IREDELL COUNTY HEALTH DEPARTMENT

IMPROVEMENT PERMIT / AUTHORIZATION TO CONSTRUCT / OPERATION PERMIT / EXISTING SYSTEM

APPLICANT: Dan Gordon APPLICANT ADDRESS: 124 Iron Gate Circle Mooresville 28117

SUBDIVISION: The Cove SECTION: LOT # 6 LOT AREA: 3.08 ac DESIGN FLOW: 720 L.T.A.R.: .3

AS BUILT SKETCH

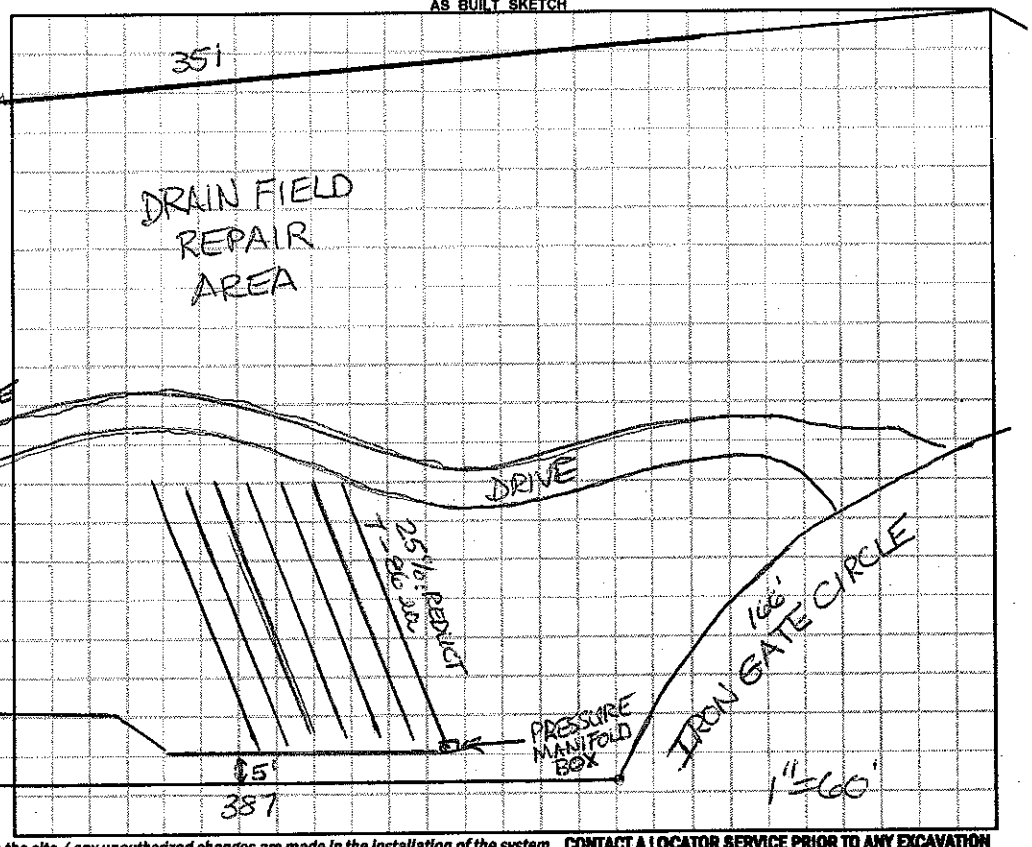
Comments / Conditions: Existing system inspection for addition of a pool only no increase to bedrooms (6 max on 720 gpd) Pool must be min 15' from all parts of septic system, tanks and repair area

Location of the proposed pool addition does not appear to impact the existing on-site septic system or well.**NOTE:
